**STAFF REPORT: 12/14/2022 MEETING**

**ADDRESS: 7441 SECOND AVENUE (AKA WJBK TV STUDIO BUILDING)**

**APPLICATION NO: #22-8155**

**SCOPE: REPLACE WINDOWS AND ROOF TO INCLUDE REMOVAL OF HVAC & TELEVISION BROADCASTING EQUIPMENT**

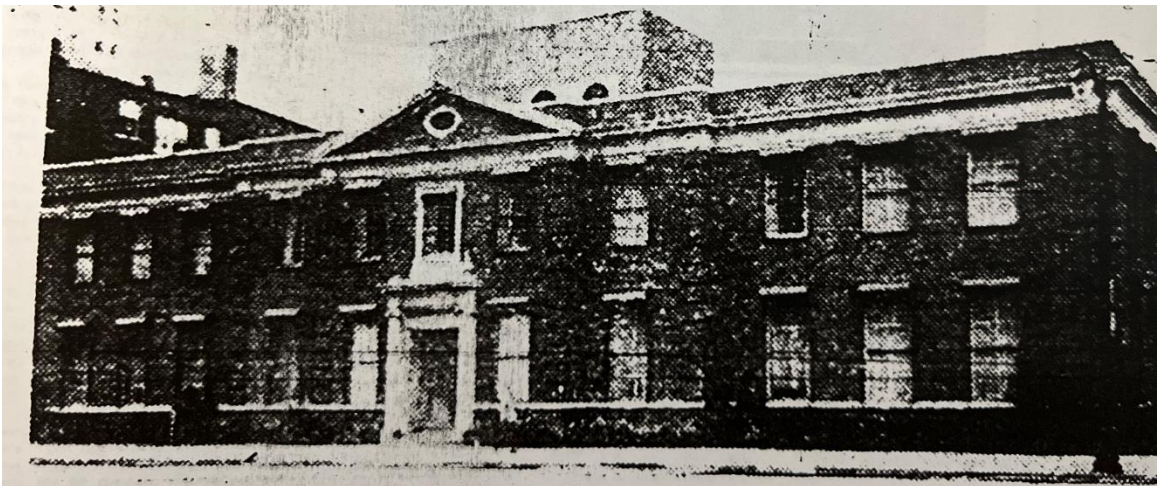
- As noted above, it is staff's opinion that the existing aluminum windows are distinctive character-defining features of the building. The current application has not presented adequate documentation that the windows display a level of deterioration that merits their wholesale removal/replacement. Therefore, the proposed removal of the existing windows does not meet Secretary of the Interior's Standards in staff's opinion

- Also, should the Commission approve the removal of the existing windows please note that the application narrative/scope of work states the proposed new windows will match the existing. Please see the attached drawings and narrative which provide dimensioned details for the existing and proposed new windows for comparison. Per the submission, the frame (head/jamb/sill) of the new windows is thicker/wider than the existing as it will be increased in width by about 1 1/2" to 1 3/4" all the way around. The amount of visible glass in the new window will also decrease by 4" versus the existing. Staff acknowledges that the new windows are probably the closest production match that can be found for windows of this size, as contemporary windows include thermal breaks and other factors (e.g, accommodating heavier dual-glazed panes) that increase thickness. However, in staff's opinion, this reinforces the importance of retaining the historic windows and their streamlined design. Retaining the existing window units and the addition of secondary/storm windows is a more appropriate approach in staff's opinion as the thicker frame and the reduced amount of glass of the proposed new windows will have a negative impact on the building's historic appearance.

HDC staff recommends that the Commission issue a Denial for the proposed window scope and the removal of the large rooftop antenna tower because the work does not conform to the district's Elements of Design and does not meet the Secretary of the Interior's Standards, in particular Standards #:

- The existing large rooftop broadcast antenna tower shall be retained at its current location
